RESOLUTION 2017-073
OF THE COUNCIL OF THE CITY OF FORT COLLINS
DIRECTING THE CITY MANAGER TO SUBMIT TO THE COLORADO PARKS AND
WILDLIFE COMMISSION AND OTHER AGENCIES THE CITY'S COMMENTS
ON THE FISH AND WILDLIFE MITIGATION AND ENHANCEMENT PLAN
FOR THE NORTHERN INTEGRATED SUPPLY PROJECT AND
DIRECTING TESTIMONY REGARDING THE SAME

EXHIBIT A

Technical Comments of the City of Fort Collins on the *Fish and Wildlife Mitigation and Enhancement Plan (Applicant Proposal)*, dated June 9, 2017 for Northern Water's proposed Northern Integrated Supply Project

Figure 1 - Riffle downstream of the Greeley Filter Plant.

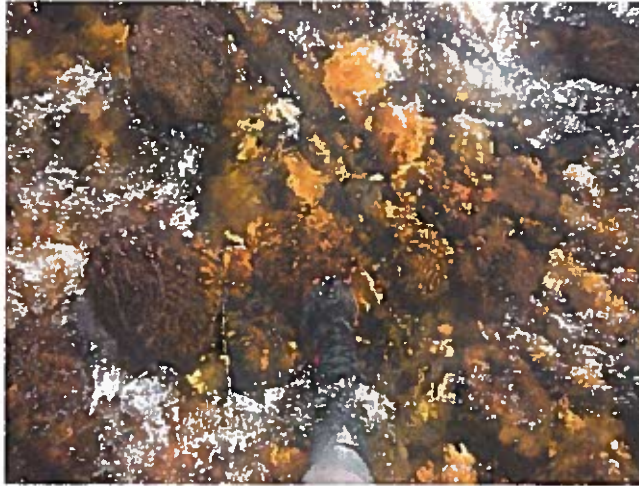
Comment: The new definition for flushing flows is not applicable to the Poudre River. A flow prescription based on this definition and its supporting analyses will be ineffective at achieving the objective of maintaining spawning habitat for fish.

In the vast majority of riffles along the Poudre River, gravels up to 64mm do not sit on top of a coarse armor layer. Rather, the smaller gravels sit among and within the larger bed material and help make-up the bed material matrix. The newly-proposed definition of "flushing flows" is thus incompatible with the Poudre River bed.

The following photos show the riverbed above, in, and downstream of downtown Fort Collins. The river bottom is a matrix of grain sizes and gravels sitting within the armor layer matrix, not above it.

Recommendation: To meet CPW’s goal of flushing gravels for spawning habitat on the Poudre River, Fort Collins recommends that the agencies use the original definition of “flushing flows” – not the new definition in Anderson 2017 – and then develop mitigation strategies to achieve this objective (such as the flow bypass proposal outlined in comment 1d).
